Comments from SPAWAR

NOAA Comment Clause 12 Figure 21 – S-101 Exchange Set – Class details.

SPAWAR Comment Clause 5.3

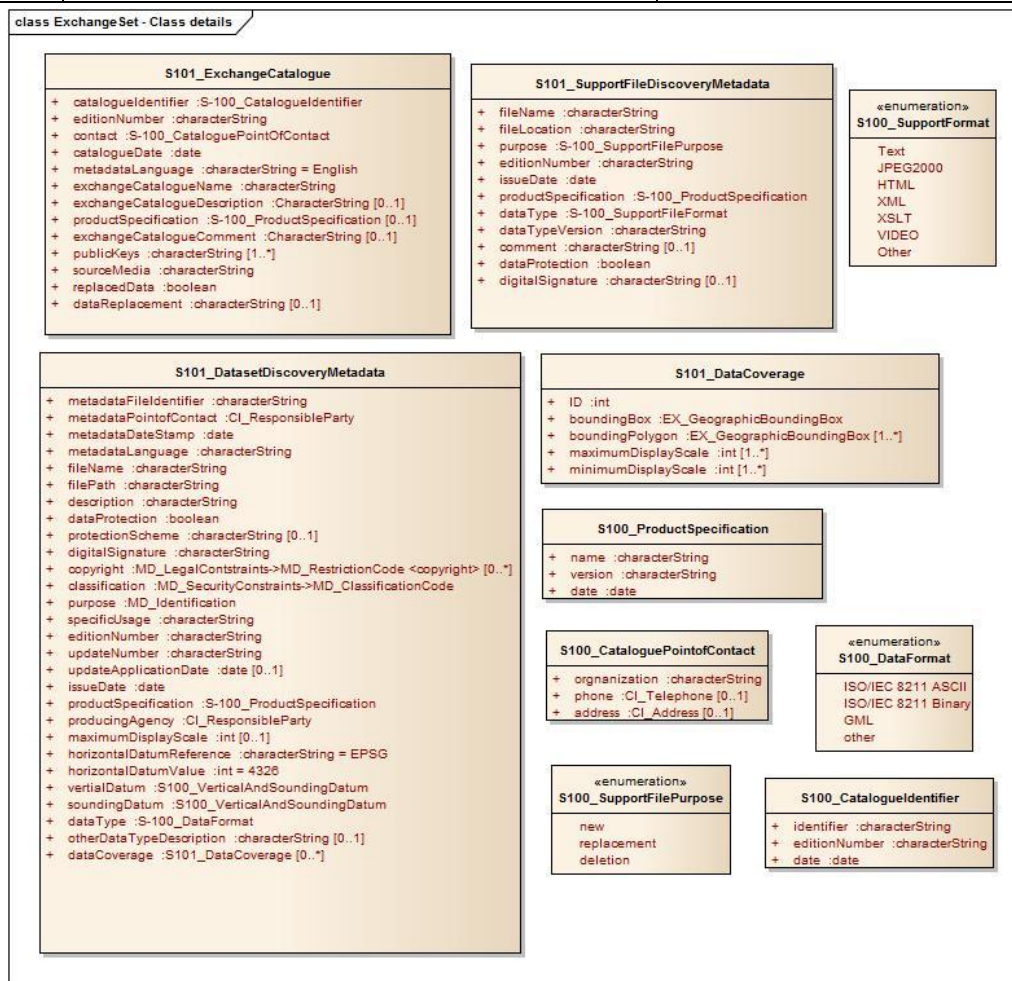
AXUM	4	Axis Unit of Measure (4 = Metres)				
VDAT			Vertical Datum				
	DTNM	mean high water	Datum Name				
	DTID	16	Datum Identifier (16 = Mean High Water)				
	DTSR	2	Datum Source (2 = Feature Catalogue)				
	SCRI		Datum Source Information (omitted)
